QUESTIONS from Geosciences and Geotechnical Engineering Branch 1 (RGS1)

FPL RESPONSE:

Proposed Turkey Point Units 6 and 7
Docket Nos. 52-040 and 52-041
FPL Revised Response to NRC RAI No. 02.05.04-19 (eRAI 6006)
L-2014-111 Attachment 18 Page 30 of 35

Proposed Turkey Point Units 6 and 7
Docket Nos. 52-040 and 52-041
FPL Revised Response to NRC RAI No. 02.05.04-20 (eRAI 6006)
L-2014-111 Attachment 19 Page 9 of 9

Figure 1 Active Earth Pressure Considering a 500 psf Surcharge on Fill

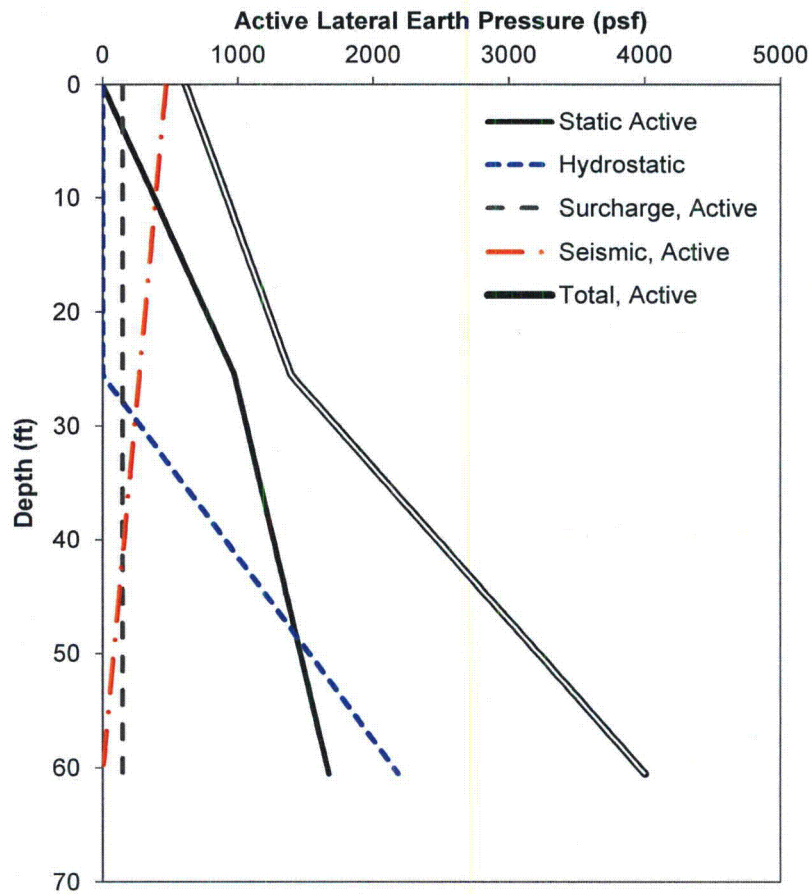
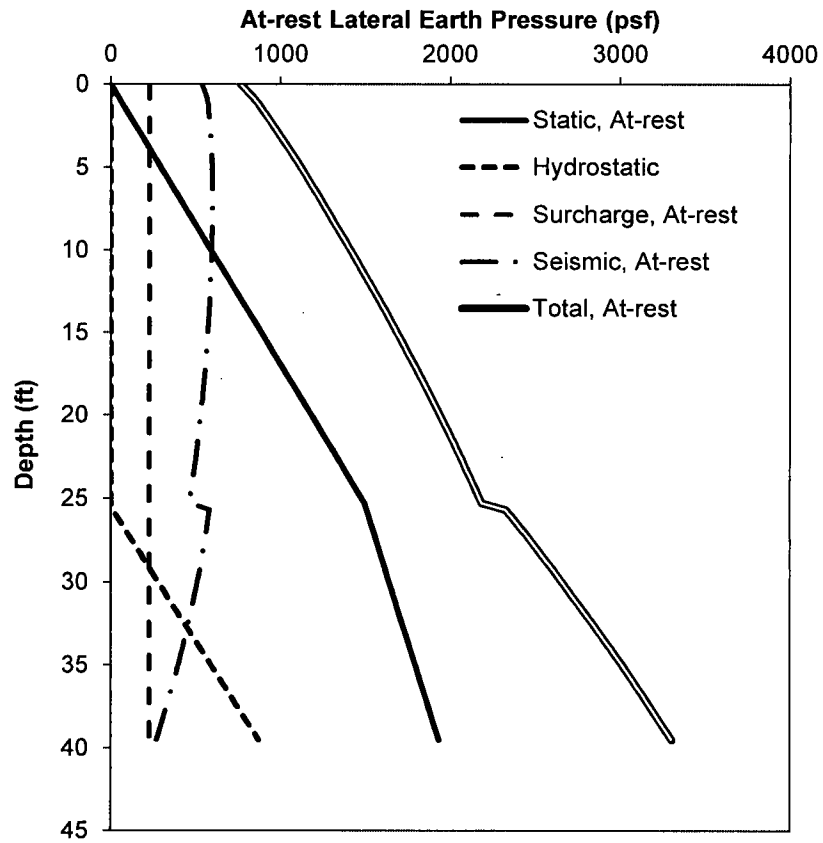
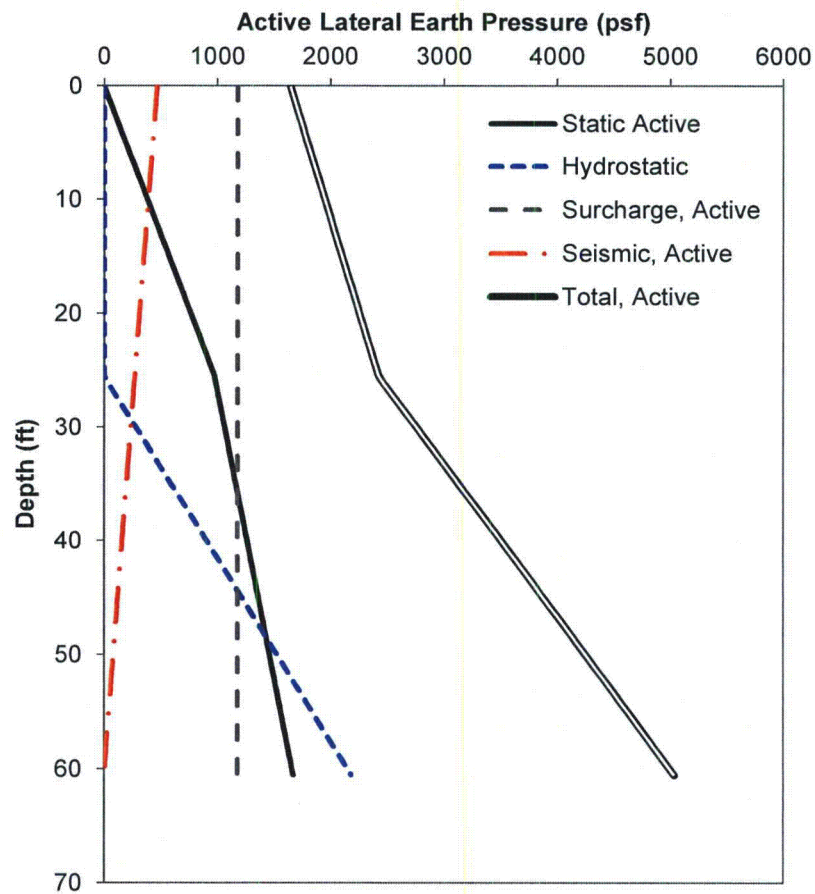
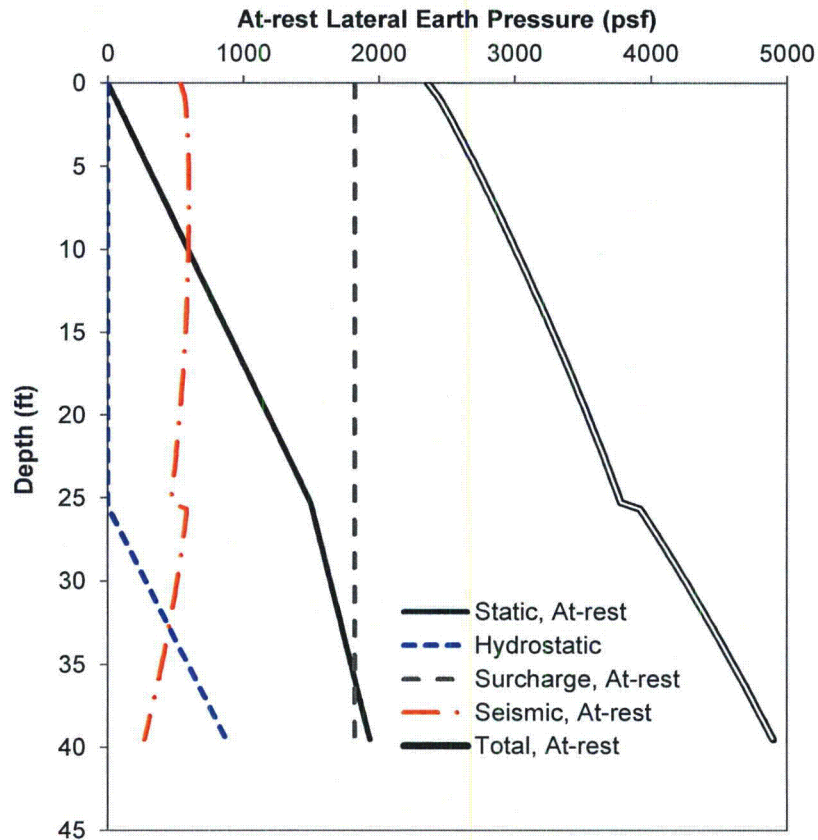
FSAR Section 2.5.4.10.4.3 states that a surcharge pressure of 500 psf was included when calculating the lateral earth pressures, however the calculation for COL static and seismic lateral earth pressures states that the adjacent building loads and the equipment loads were not considered. In accordance with NUREG-0800, Standard Review Plan, Chapter 2.5.4, "Stability of Subsurface Materials and Foundations," please describe the selection of 500 psf.

As indicated in FSAR Subsection 2.5.4.10.4.3, an area-wide surcharge pressure of 500 pounds per square foot (psf) is included in the earth pressure calculations. For the active condition presented in Figure 1 and for the at-rest condition presented in Figure 2, this loading represents the temporary construction loading, and does not include the permanent adjacent building loads. As indicated in FSAR Subsection 2.5.4.10.4.3, the validity of this pressure will be reviewed during the detailed design phase. This temporary loading is conservatively twice the typical design pressure for heavy truck loading (Reference 1).

To address adjacent building loads, an additional case considering a surcharge pressure of 4000 psf is presented in Figures 3 and 4. This surcharge is adopted because it is the highest expected building bearing pressure for the buildings founded on fill around the nuclear island. This pressure will also be reviewed during the detailed design phase.

FSAR Figure 2.5.4-239 Lateral Earth Pressure Diagram: Active Case
Pressure Considering a 500 psf Surcharge on Fill

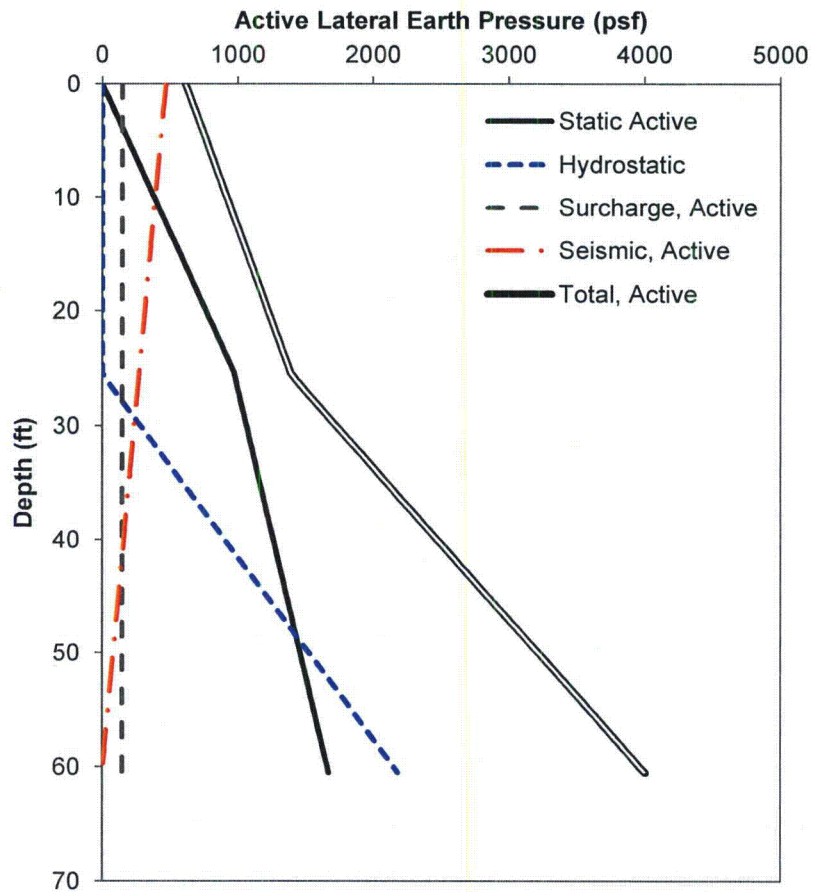
FSAR Figure 2.5.4-239 will be replaced with the following figure in a future revision:

FSAR Figure 2.5.4-240 Lateral Earth Pressure Diagram: At-Rest Case
Pressures Considering a 500 psf Surcharge on Fill

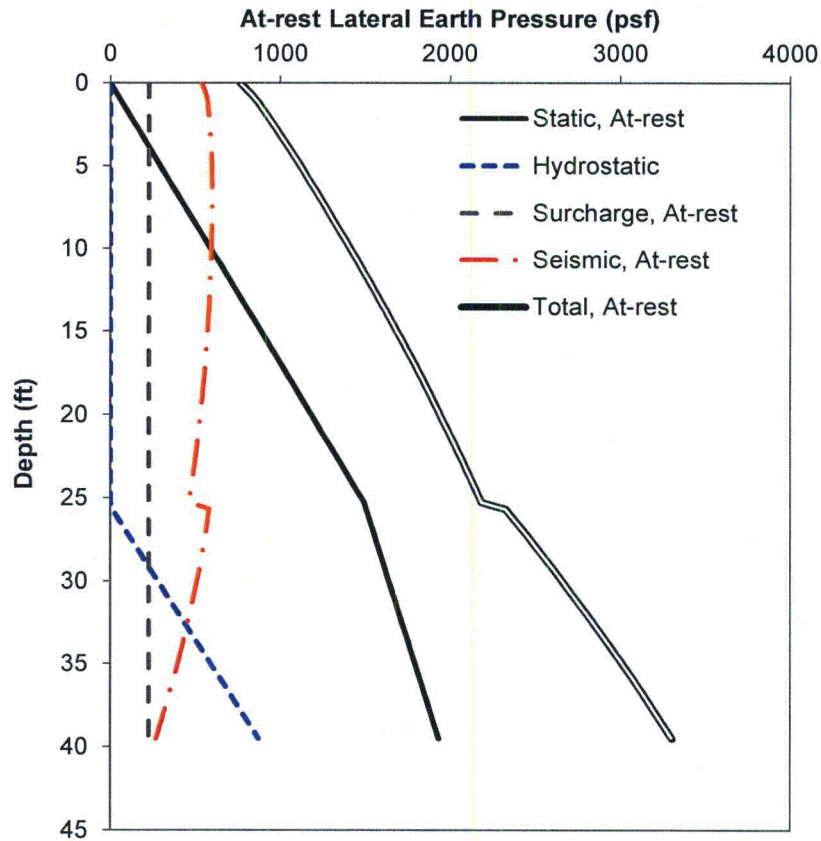
The lateral earth pressure diagram shown in Figure 2.5.4-240 shows a plot corresponding to the dynamic lateral earth pressure. The shape of this plot appears to be consistent with the shape for dynamic pressure considering a rigid structural wall (see ASCE 4). In Section 2.5.4.10.4.2 "Seismic Lateral Earth Pressures", the active seismic pressure was computed using the Mononobe-Okabe equation. The last sentence of the section indicates that at-rest pressure as a function of depth for below-grade walls is developed consistent with Reference 277 (ASCE-4) using the design ground motion. It is noted that the pressure developed using the ASCE-4 methodology uses the z_{pa} value from the input motion.

FSAR Figure 2.5.4-240 will be replaced with the following figure in a future revision:
